Groundwater Transfer Review Summary Form

Transfer/PA # T- 14580 (RA)

Ground Water Review Form:

Application: T-14580

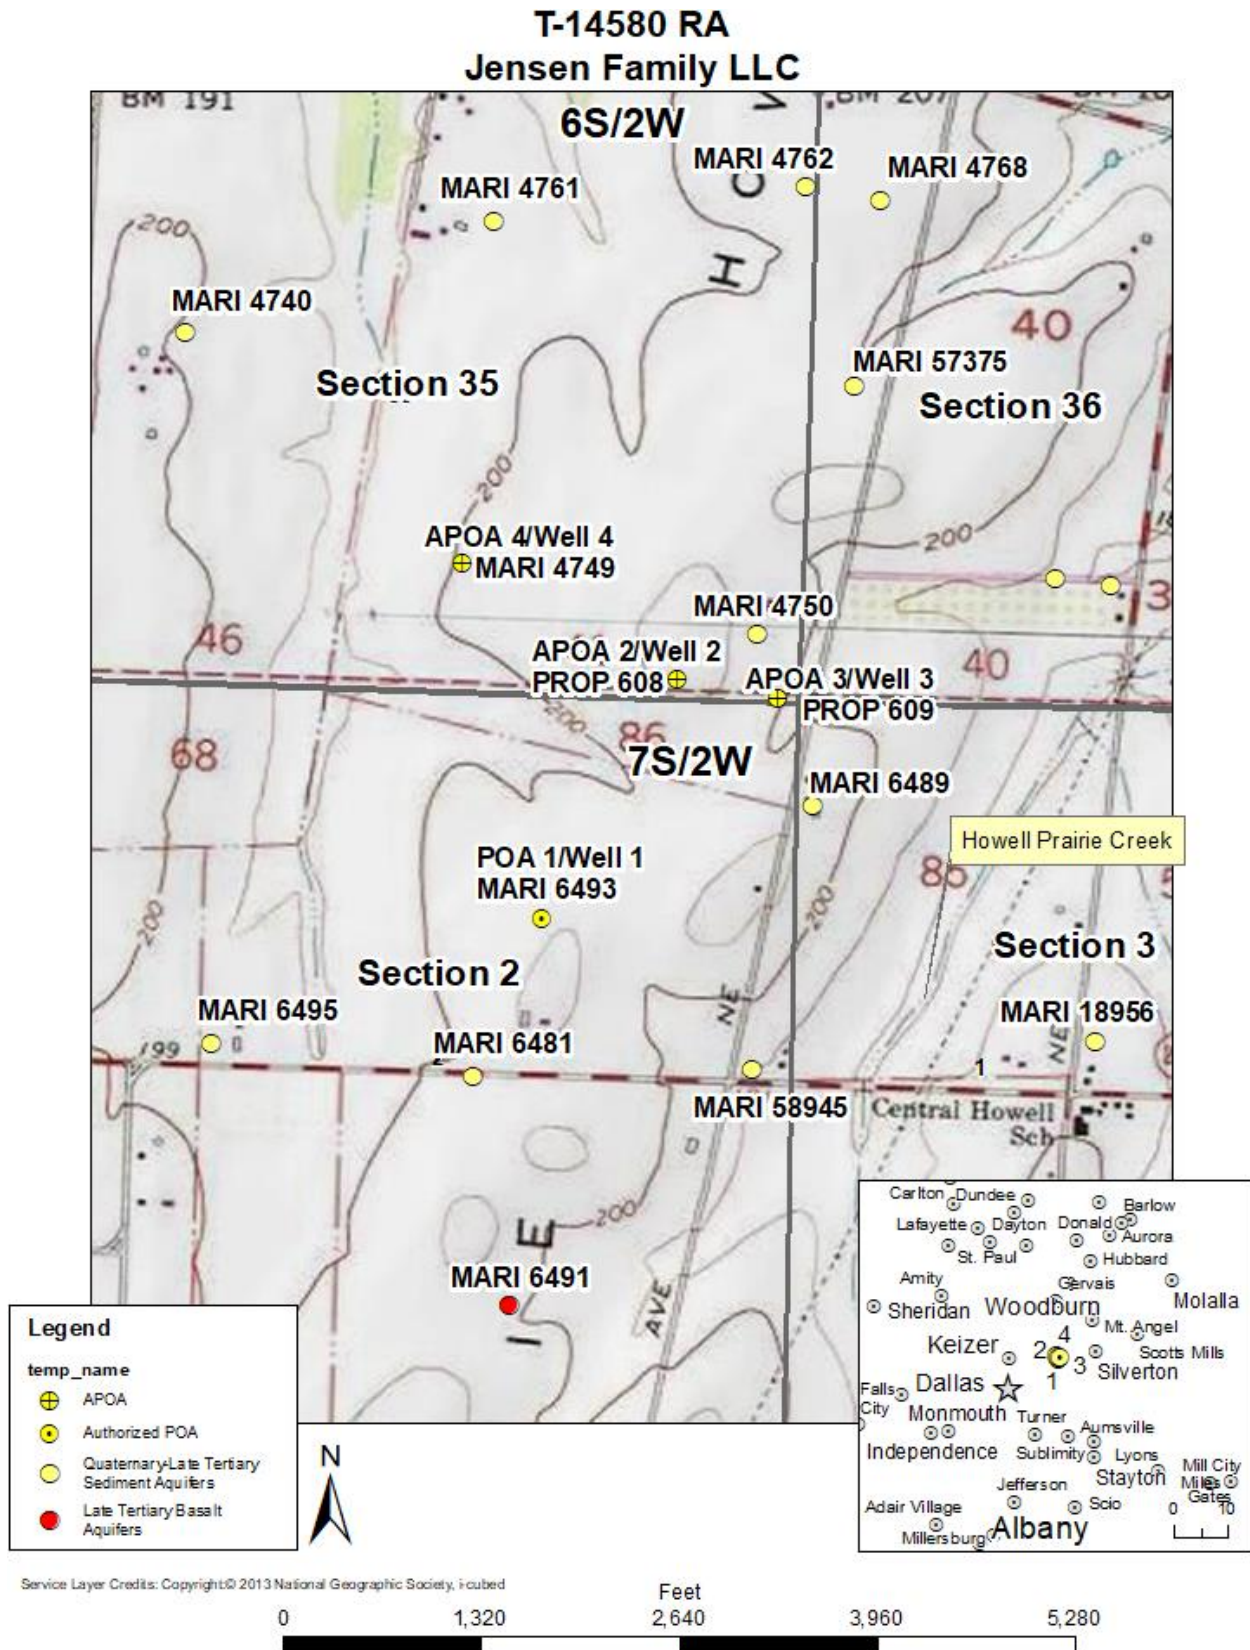
Radial distance from pumping well (r)=750 ft [estimated radial distance to nearest user, MARI 6489]

Pumping Rate (Q)= 1.0356 cfs (~464.78 gpm)*

Aquifer Transmissivity (T1)= 1,497 gpd/ft (200 ft²/day), (T2)= 4,115 gpd/ft (550 ft²/day), (T3)= 32,060 gpd/ft (4,286 ft²/day)

Storativity (s1) = 0.0003, (s2) = 0.02 [Conlon et al 2005, Table 1 values for MSU]

Total pumping time= 245 days [March 1-October 31]

*The full pumping rate could not be utilized continuously for the entire 245-day period of use without exceeding the 503.25 ac-ft maximum allowed duty. For the maximum allowed duty of 503.25 ac-ft, continuous pumping would occur for 245 days at a rate of 1.0356 cfs (~464.78 gpm)

Map

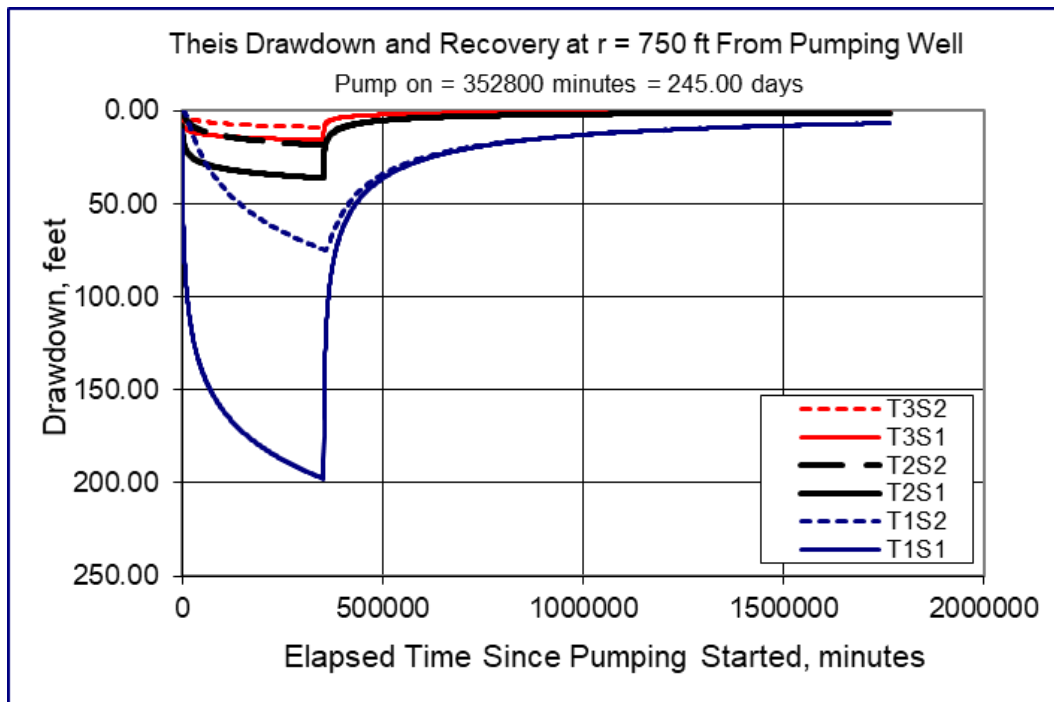
☒ Yes ☐ No Comments: Proposed APOA 3/Well 3 (PROP 609) is ~750 ft northwest of MARI 6489, a POA on Certificate 47840 with priority date 5/23/1973. The authorized POA/POA 1 (MARI 6493) is ~1956 ft southwest of MARI 6489. The reduced distance is anticipated to increase interference with MARI 6489.

☐ Yes ☒ No If yes, explain: The maximum drawdown produced by APOA 3/Well 3 (PROP 609) is not anticipated to result in MARI 6489 not receiving the water to which it is legally entitled.
